Conceptual Review Agenda

CONCEPTUAL REVIEW PACKAGE FOR HEADQUARTERS OF BLUE OCEAN ENTERPRISES AND PARKING GARAGE WITH COMMERCIAL BUILDING

Re: 111 S Meldrum St - Mixed Use

Description of project: This is a request for a mixed-use development located at 111 Meldrum Street (Parcel #s 97114-11-006 & 97114-56-003). The project consists of two separate buildings. The northern building would be offices, 6 stories and 42,000 square feet. The existing building at this location would be deconstructed. A second building would be constructed further south on an existing surface parking lot. This building would consist of a 2 story structure with retail, office and restaurant space. A 4-story, 450 space parking garage is attached to the building to the west. The site is located in the Canyon Avenue subdistrict of the Downtown Zone District (D). The proposal is subject to Planning & Zoning Board (Type 2) review.

OVERALL SITE PLAN

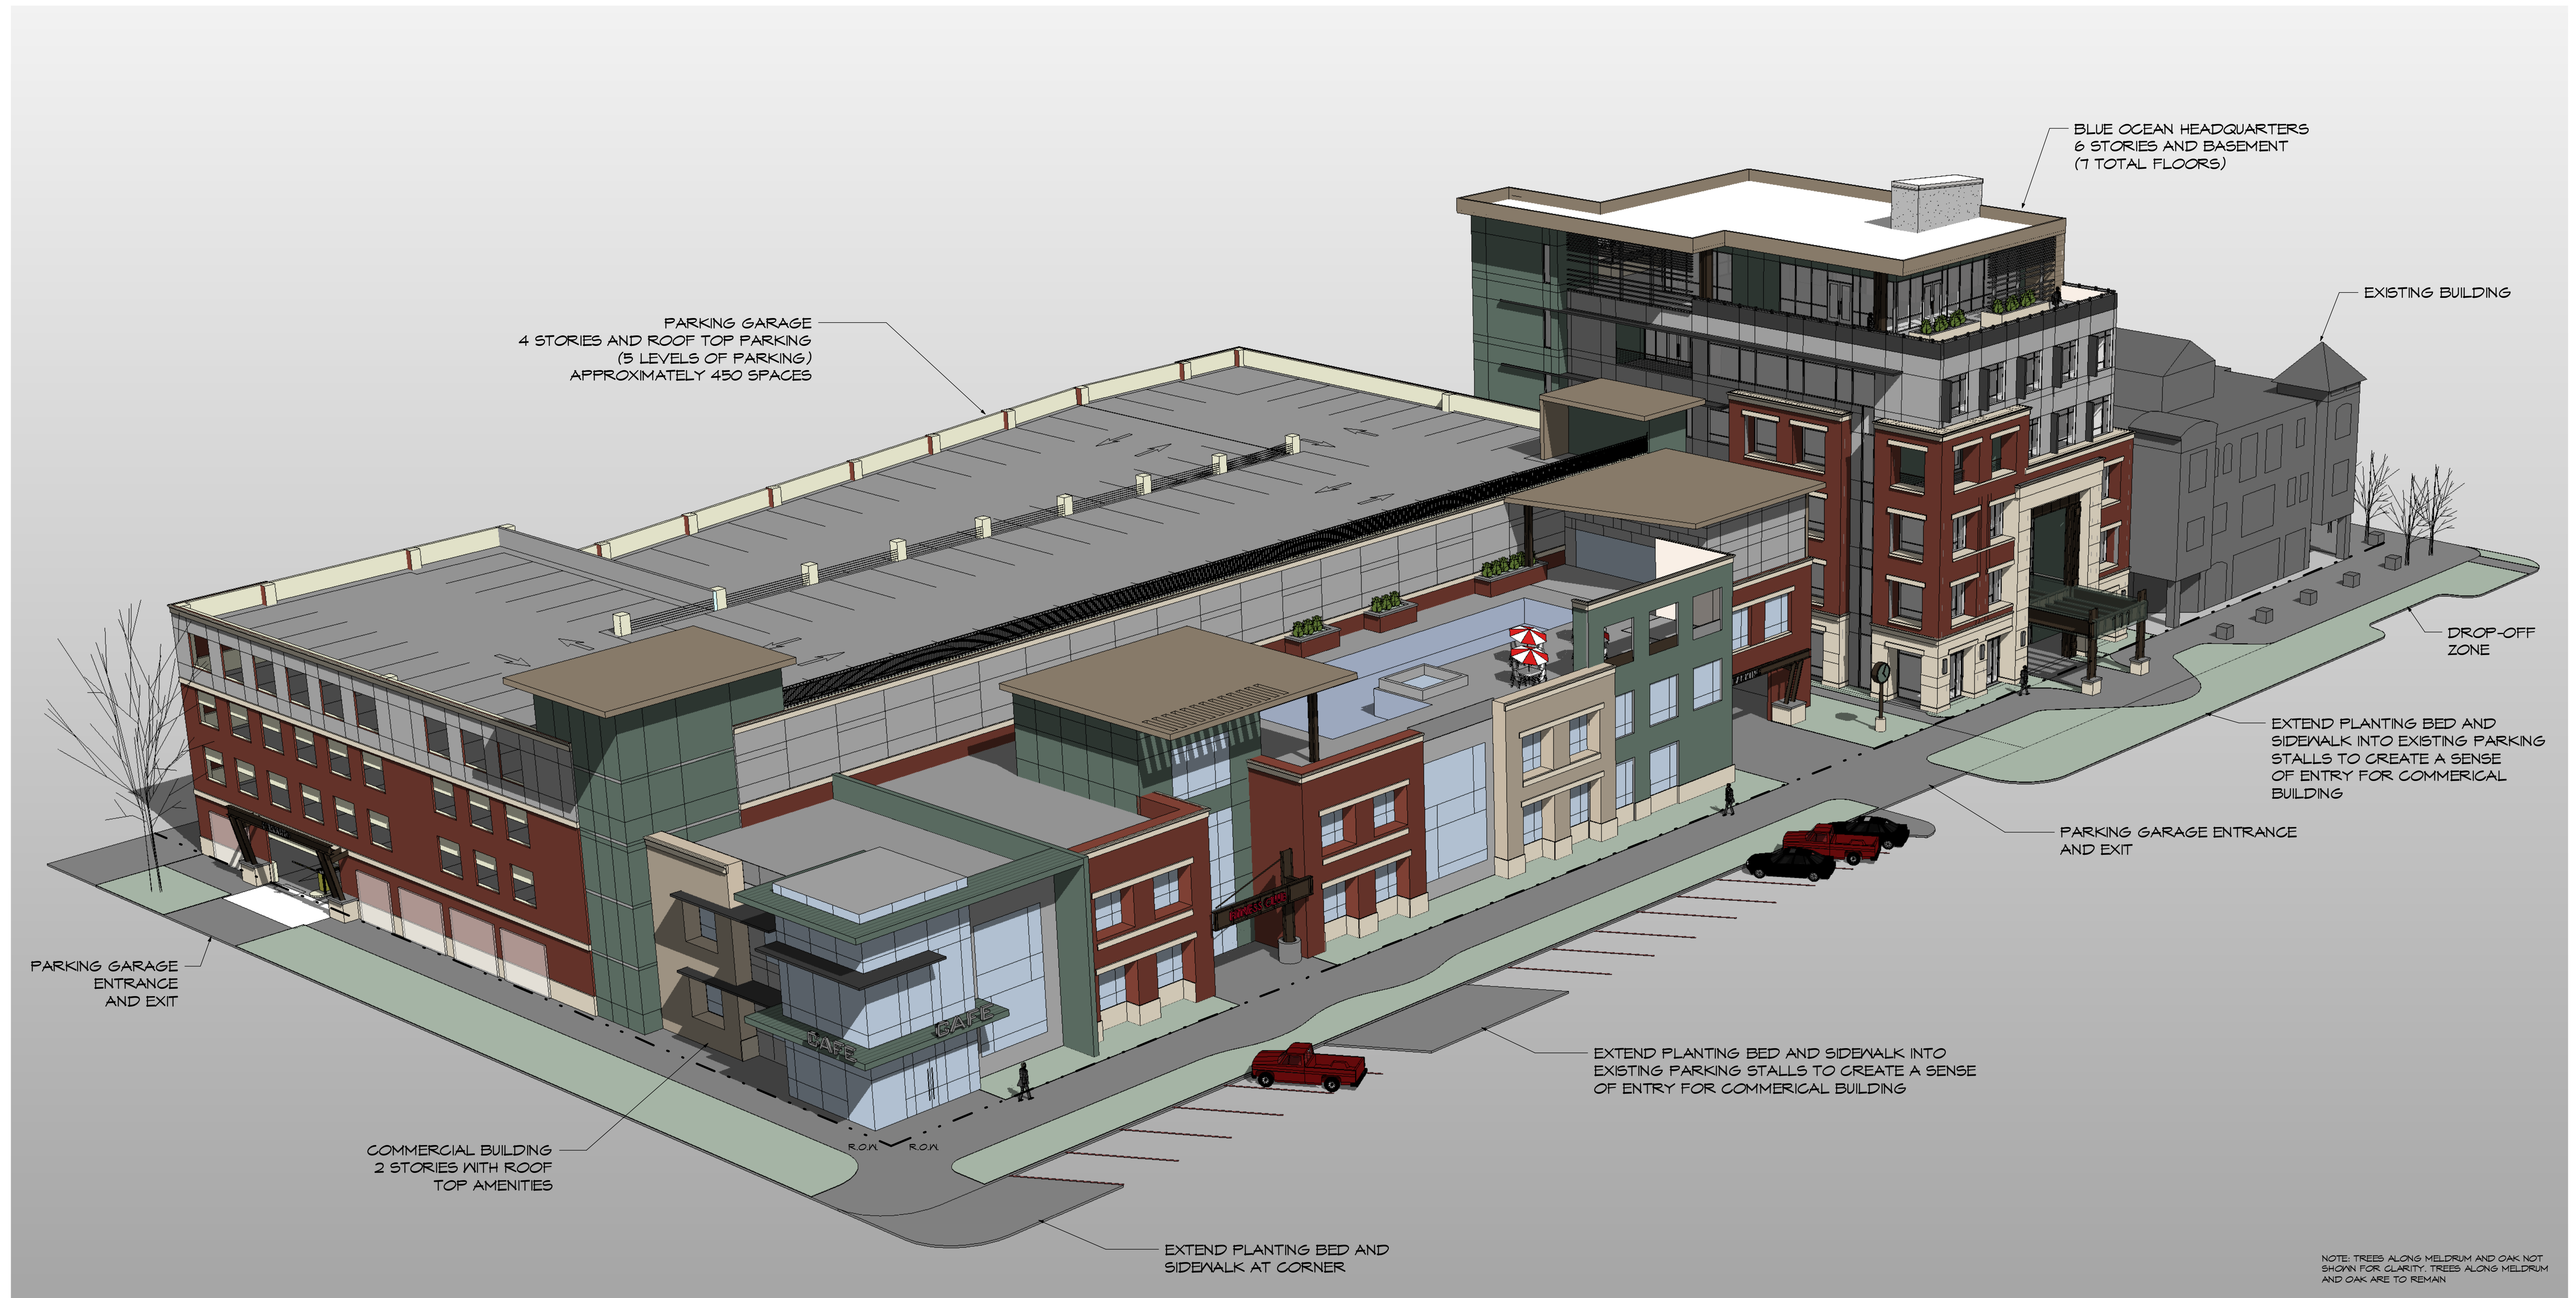
10. From the renderings it appears that Oak Street and Meldrum Street intersection is improved to an enhanced pedestrian amenity. Is it intended with this project that this intersection be improved to this condition?

11. There is an initial concern with the parking spaces that are being proposed to be removed along Meldrum Street near the intersection of Mountain Ave. Is the property on the corner at 401 Mountain Ave also owned by this projects owner? If both properties are under the same ownership than the proposed removal of parking could be supported. Additionally the loading zone parking space provided does not appear large enough for commercial deliveries as mentioned.

13. The overhang at the main entrance extends into the Public Right of Way. The City is currently in the process of creating guidelines to determine what encroachments require a revocable permit and which require a right of way easement. Right now this appears to be more consistent to requiring an easement which will need to be approved by City Council.

14. The sidewalk at the overhang canopy should extend underneath the canopy as well as wrap around the front

15. It appears that the office building will be gaining access through the back parking lot via the alley. Does the owner of this project own the property that access will be needed to be granted through? If the property is not owned by the same owners than an access easement will need to be provided if there is not already one.
16. Parking garage vehicle entrances can be a safety concern to pedestrians on sidewalks adjacent to these entrances. Consider recessing the vehicle entrance to provide sight distance for vehicles exiting.
17. It appears that the Alley adjacent to this project is currently paved. However, the condition of the alley will need to be documented and could potentially need to be brought up to standards or repaired as a part of this project.

1 MELDRUM ST. ELEVATION

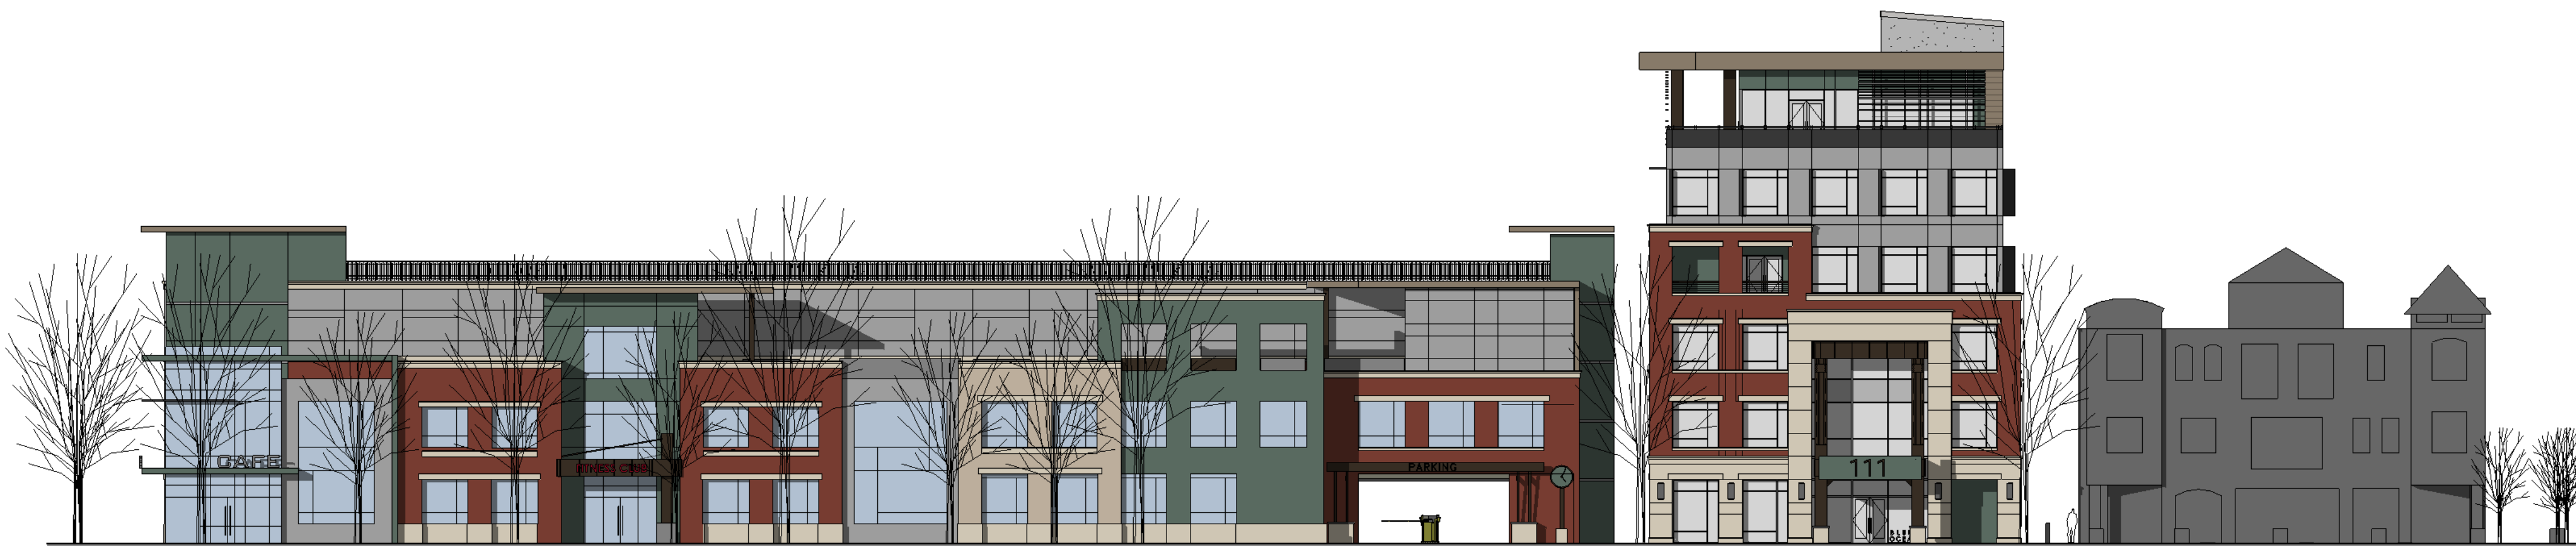
2. To mitigate the sheer height of the six story building on Meldrum, a larger stepback should occur at the fourth floor to make it more consistent with the existing building on the corner and be more human scale.

2 SECOND FLOOR PLAN
 SCALE 1/16" = 1'-0"

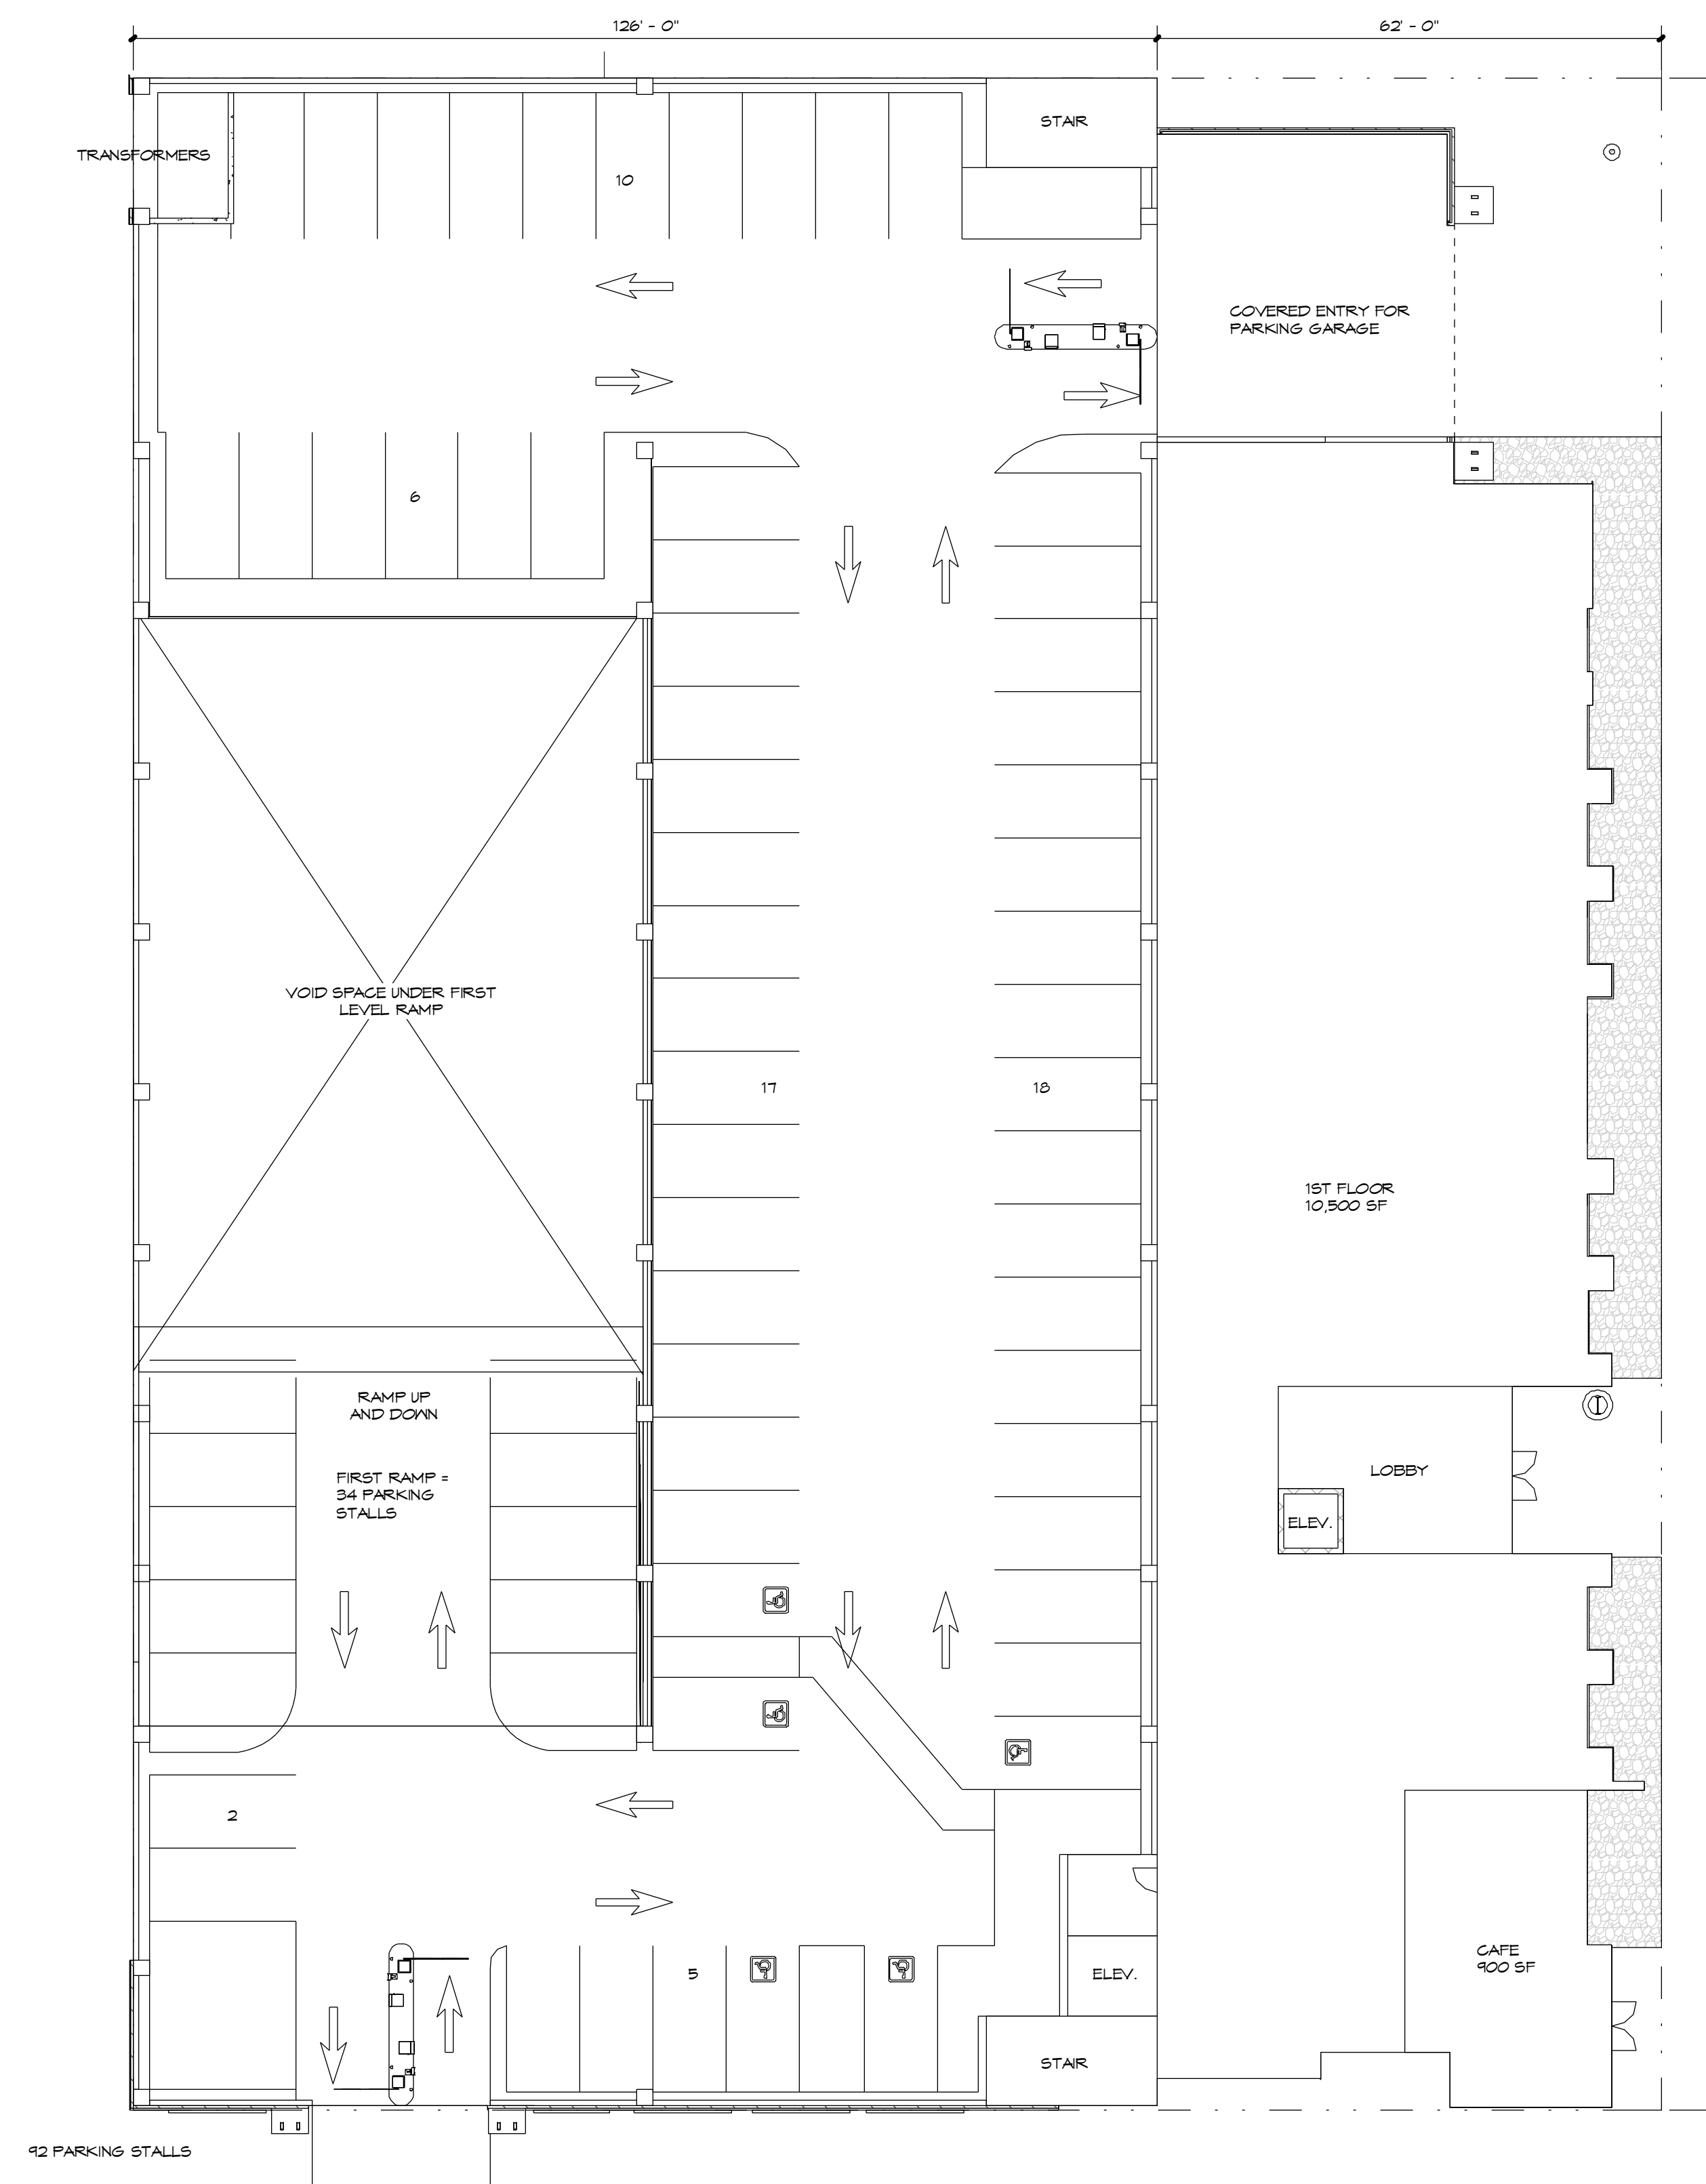
2. LUC 3.5.3(E)(2)(a)1. No wall that faces a connecting walkway shall have a blank, uninterrupted length exceeding 30 ft (see section for options).

Not sure if the North wall of the parking garage is meeting this standard.

Where is the enclosure for the retail/parking structure?
